DEVELOPMENT REVIEW COMMITTEE (DRC) COMMENT REPORT

PROJECT NAME: Seagis Palm Crossing

CASE NUMBER: UDP-S23031

REQUEST: Site Plan Level II Review: New 92,224 Square Foot Wholesale Distribution Center

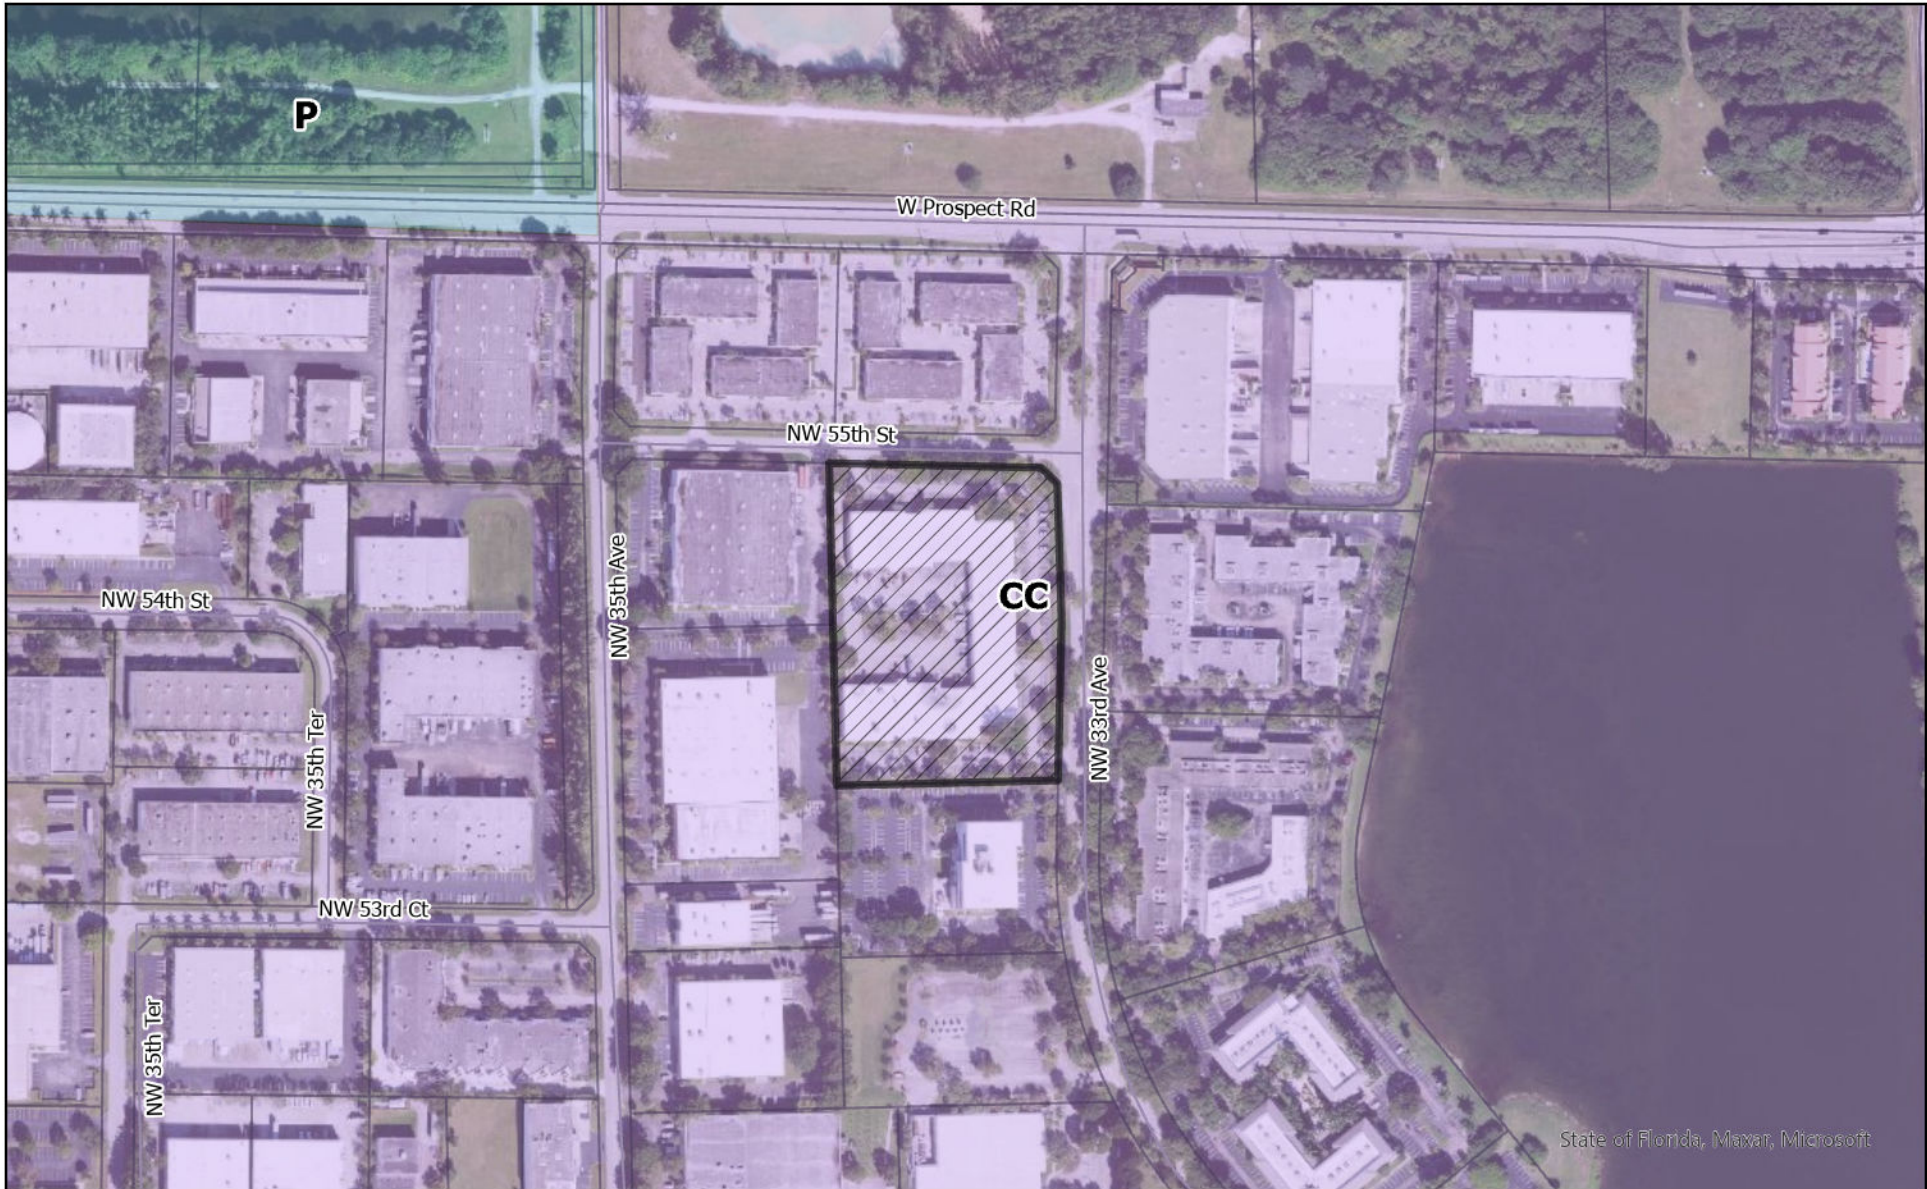
9. Provide the following changes on elevations:
 - a) Include additional materials to differentiate and highlight building features other than scored/painted stucco.
 - b) Additional architectural emphasis needs to be placed on each of the elevations to break up building massing, with specific emphasis placed on building corners and entrances. See example below.
 - c) Incorporate overhangs, awnings, material banding and other architectural elements that soften the building's features and provide relief from large blank walls.
 - d) Consider additional roofline articulation to provide visual interest and to break the extensive linear roofline.
